ADDENDUM #1 TO THE TECHNICAL DRAINAGE STUDY

FOR
Red Rock Elementary School

DS-05647

**ADDENDUM #1 to the Technical Drainage Study for Red Rock Elementary School
CLV #5647**

FIGURE 6

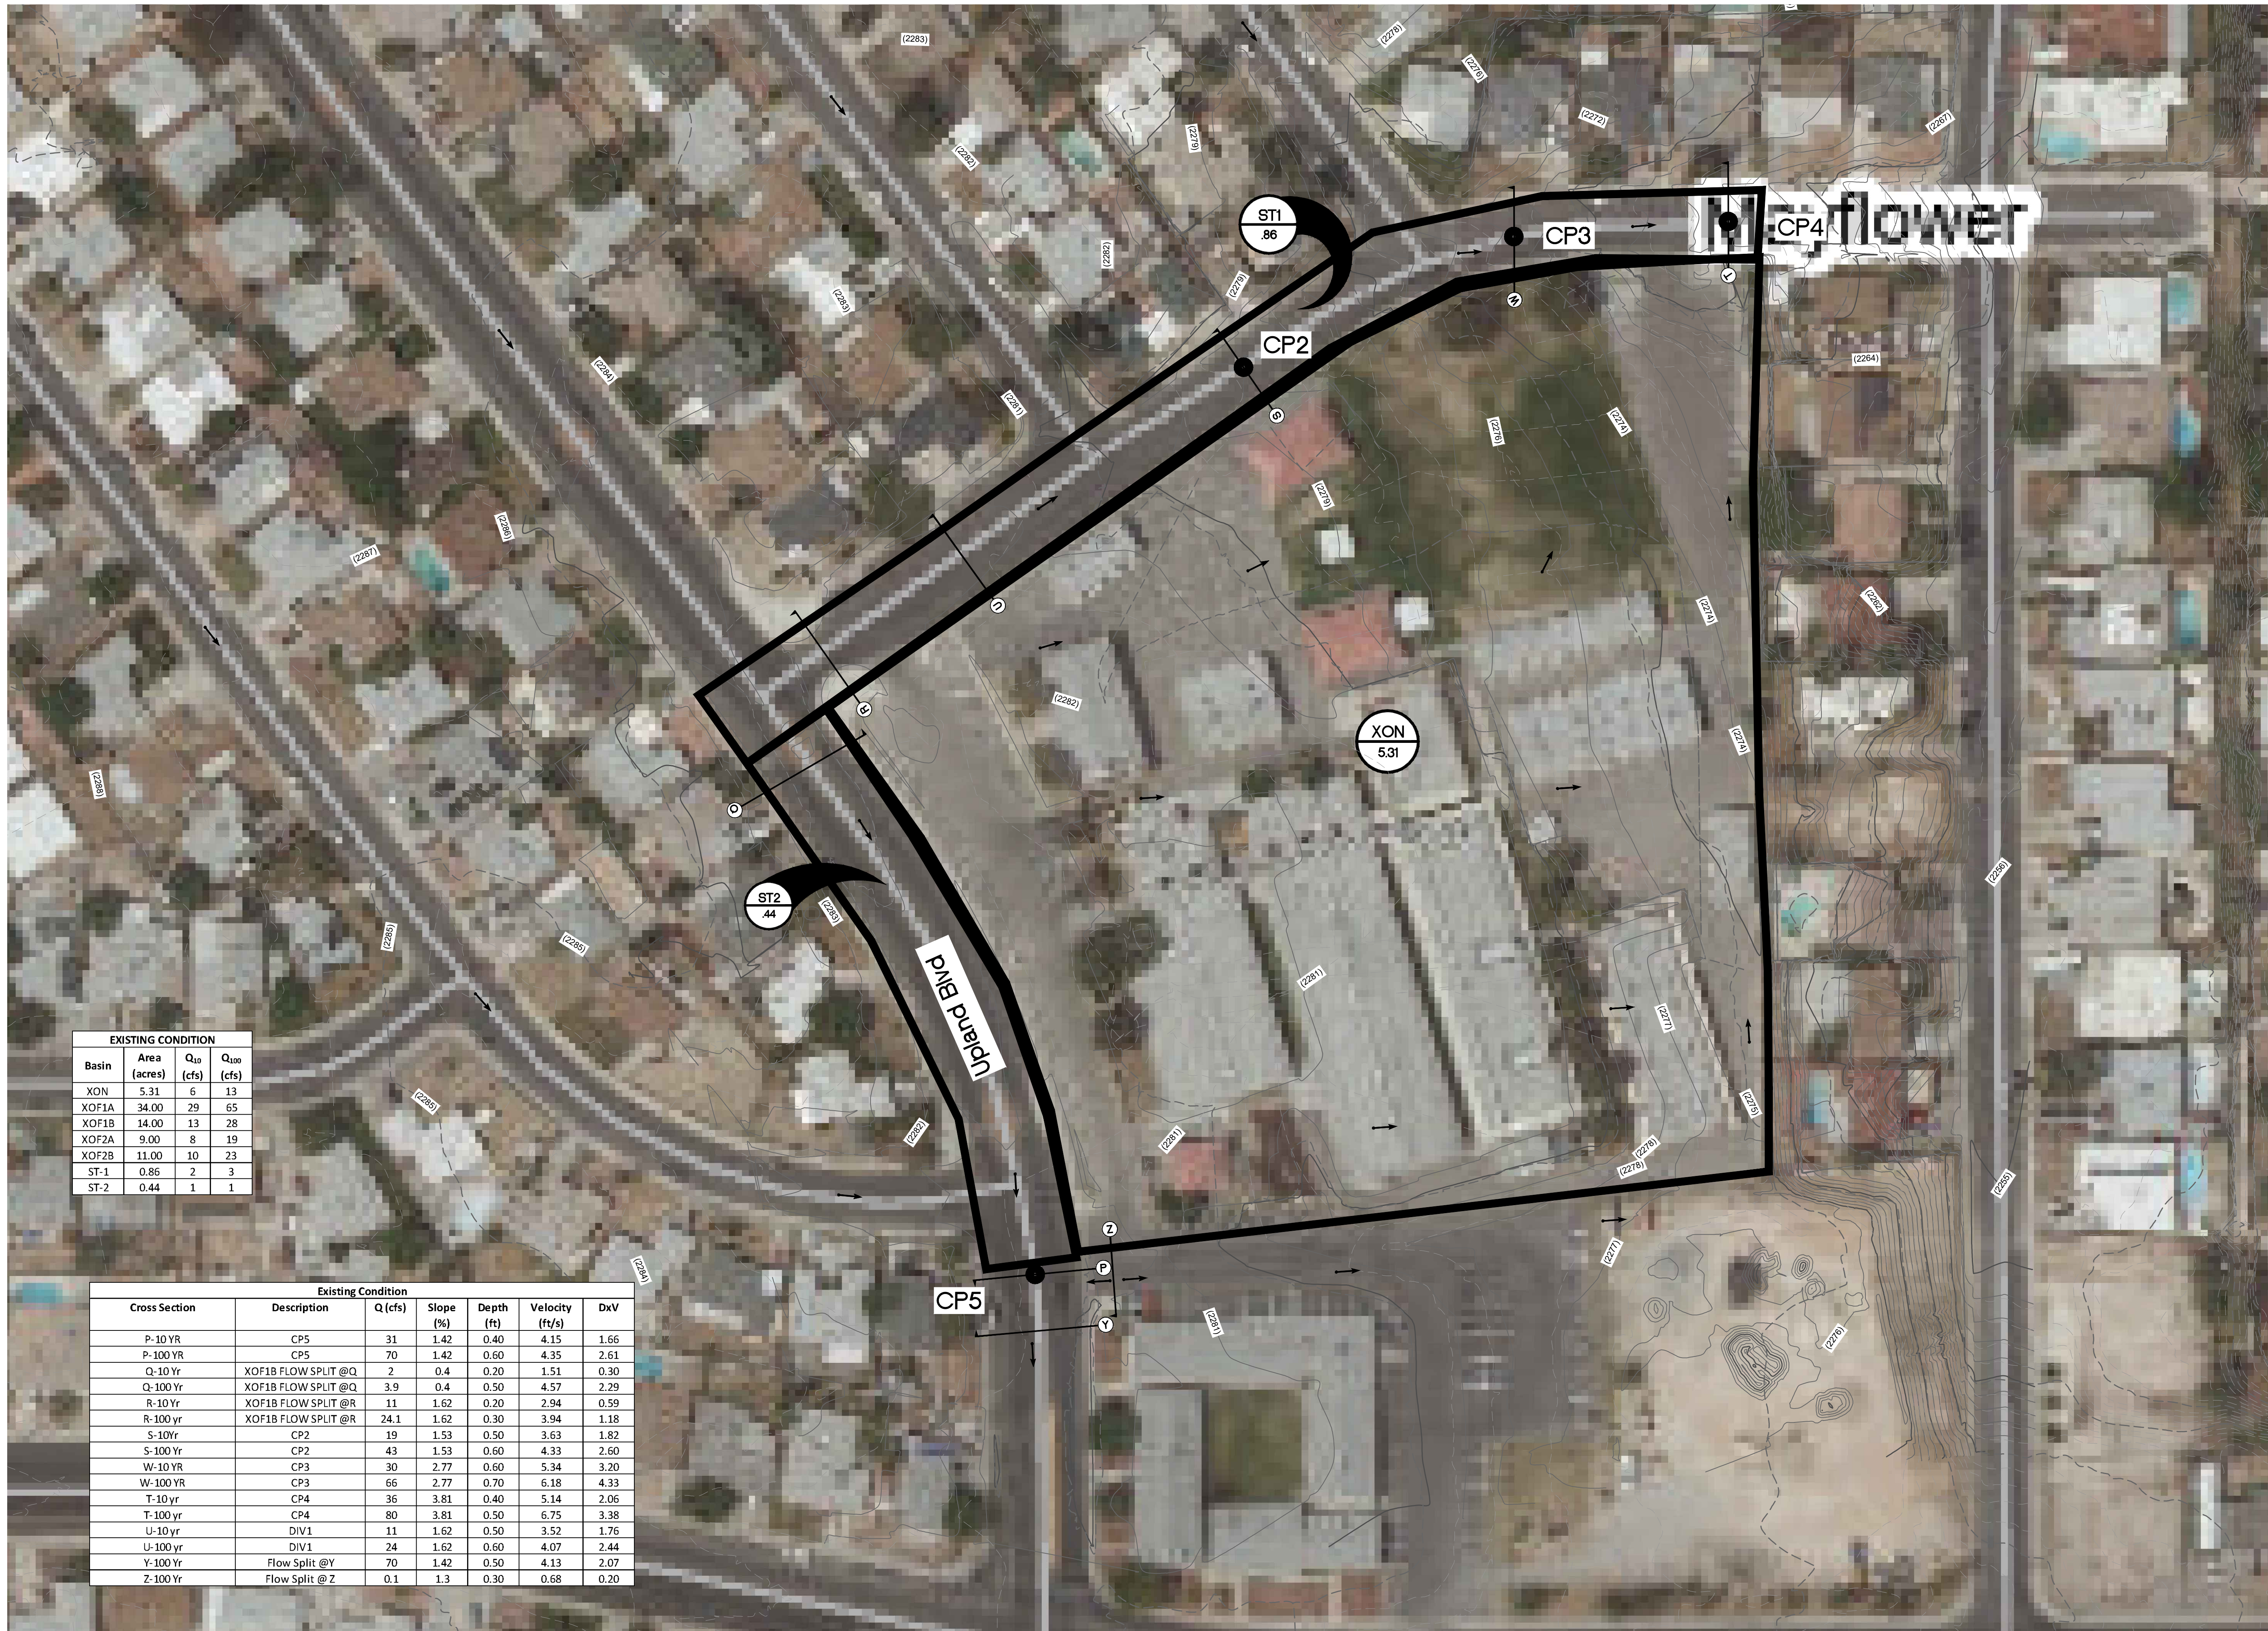
Comment 4: From the provided Existing Condition Map, Figure 6, the contour on the southern boundary looks as if it is flowing east towards Falcon Lane and not north towards Mayflower Lane. Provide additional reference materials to show if the entirety of the existing project site is meant to flow north toward Mayflower Lane.

Comment 6: Existing Condition Map, Figure 6: The figure shows Basin XON while Standard Form 4 lists Basin XON1. Review and revise accordingly.

The flow split analysis was conducted for Upland Boulevard and southern driveway of project site using Water Surface Elevation Method (WSE) in flowmaster. The difference in water surface elevation between Upland Boulevard and southern driveway was used to determine the direction of flow from the concentration point CP5. It was found that WSE on Upland Boulevard was lower than that of southern driveway, indicating that the highpoint on the southern driveway is high enough to protect the site from 100- Yr flow. The flow split calculation can be found in Appendix D with this submittal.

Standard Form 4 and HEC-1 have been revised to match Exhibit.

FIGURE 7

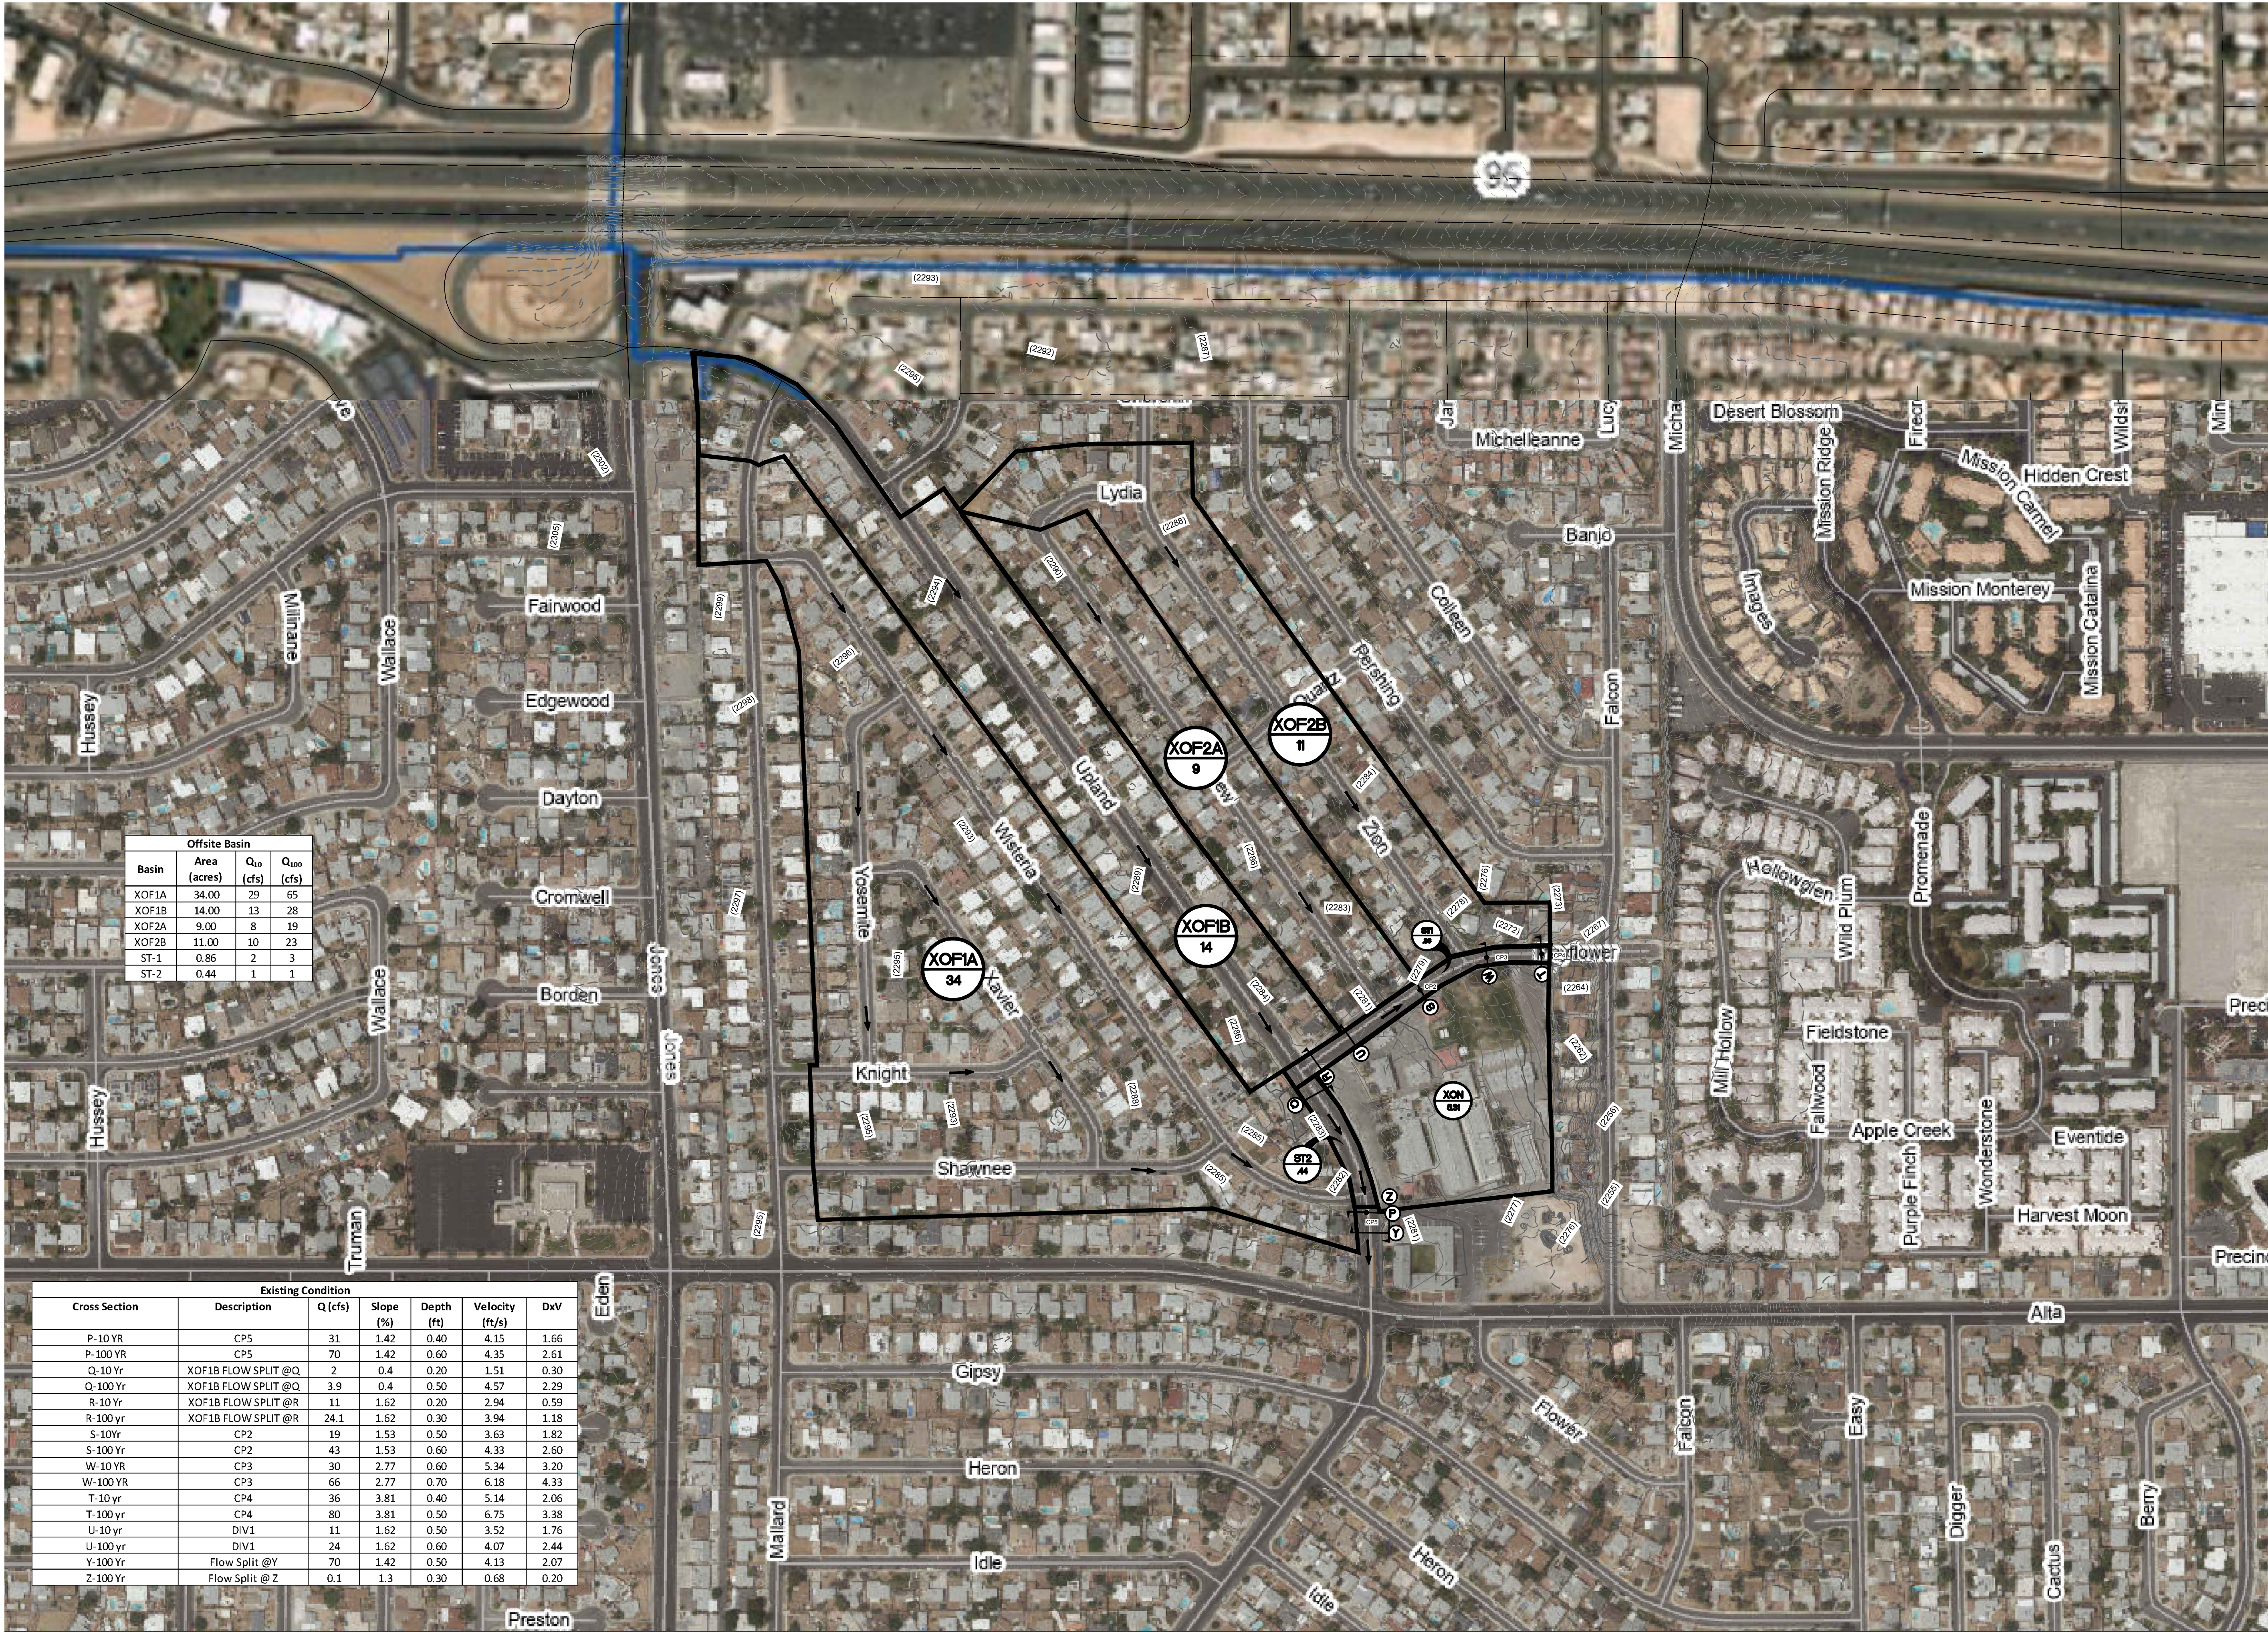
Comment 7: Developed Condition Map, Figure 7: Add a slopes column for the Developed Condition cross section summary table.

Developed Condition Map, Figure 7 has been revised and slopes column has been added to the cross-section summary table.
